Economic Commission for Europe
Inland Transport Committee
World Forum for Harmonization of Vehicle Regulations
Working Party on Noise
Sixty-sixth session

Geneva, 4-6 September 2017

**Report of the Working Party on Noise
 on its sixty-sixth session**
Contents

Adopted amendments to Regulation No. 51 (based on ECE/TRANS/WP.29/GRB/2017/6)

Figure 2: Flowchart for the check on the necessity for a silencer conditioning test

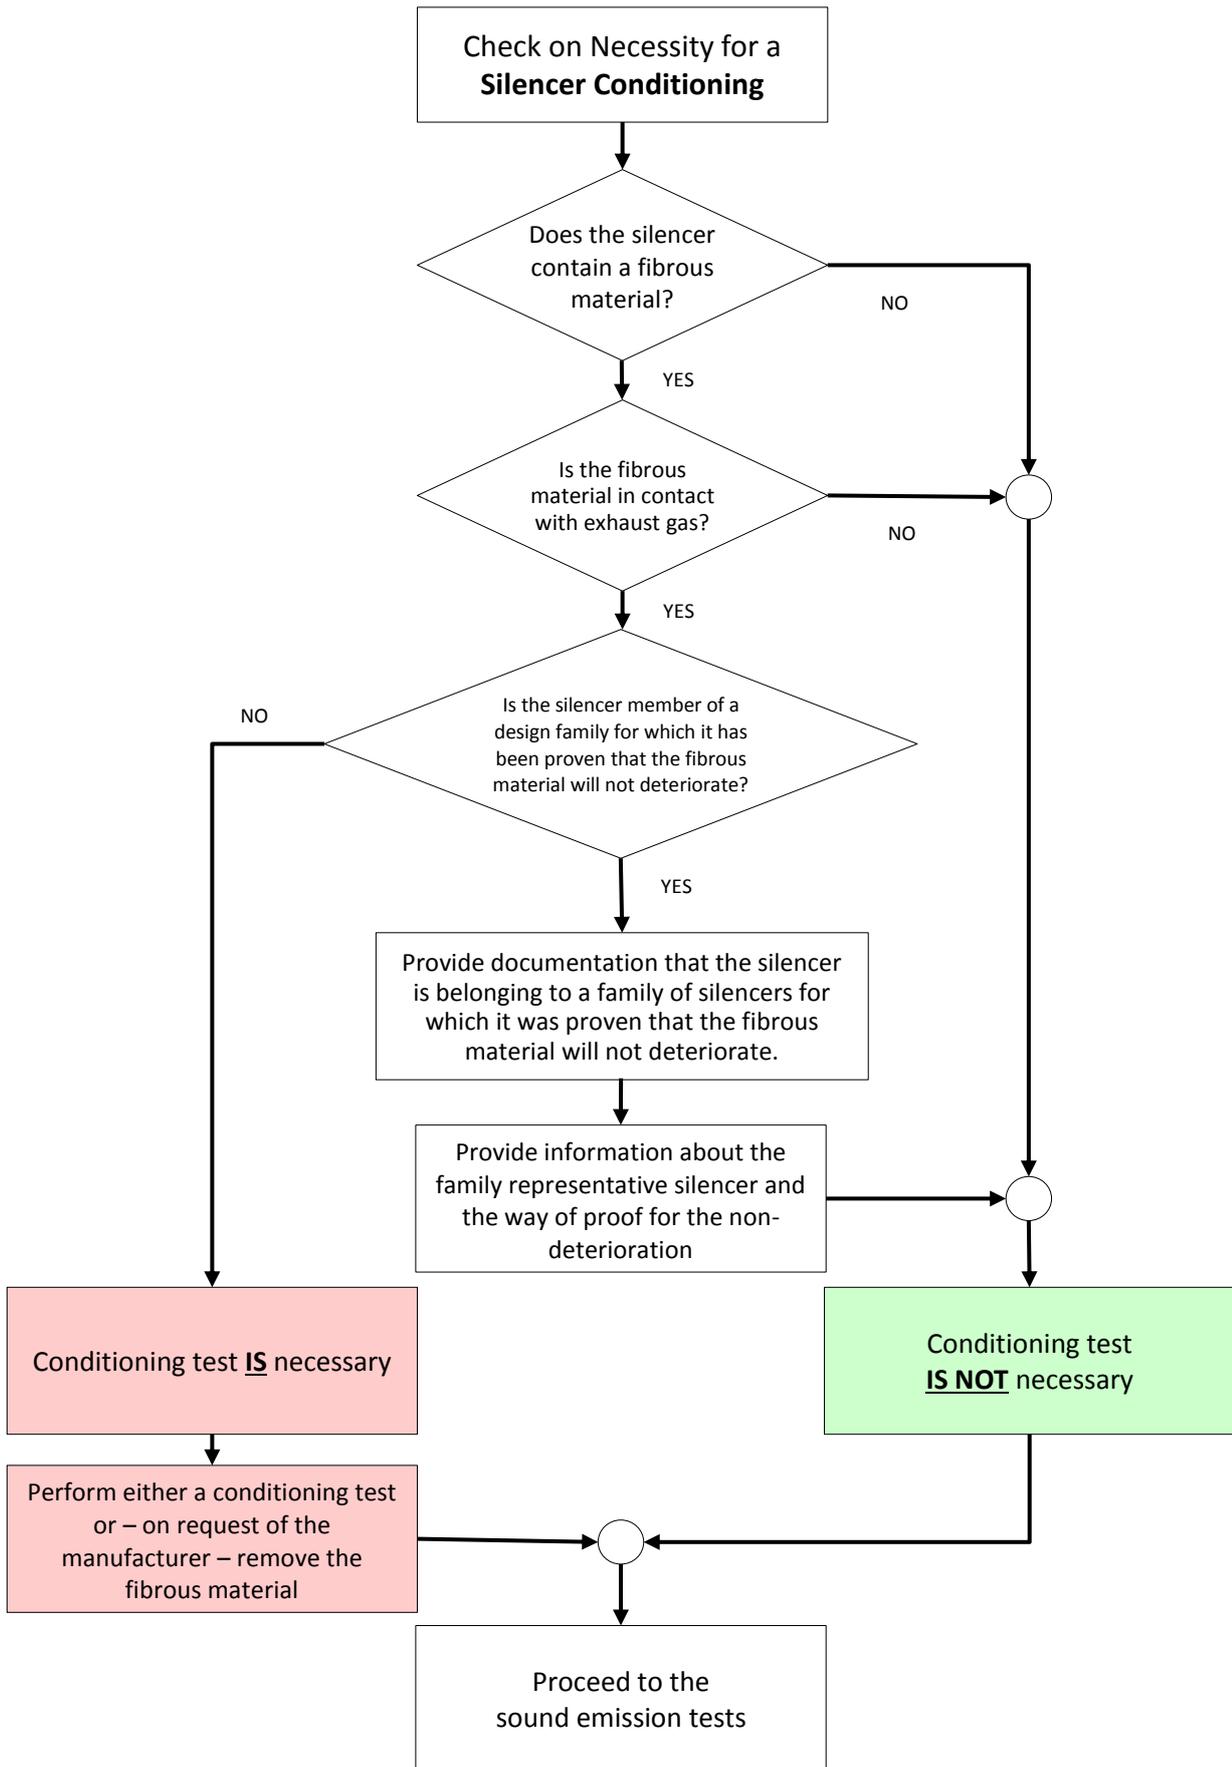
"2.2.6. If the vehicle is equipped with an exhaust system containing fibrous materials, ~~the exhaust system is to be conditioned before the test according to Annex 4~~ it might be necessary to carry out a conditioning test prior to testing. The provisions of Annex 4, paragraph 1 in conjunction with the flowchart (figure 2) of the appendix to Annex 4 shall be followed."

Appendix, add a new flowchart to read:
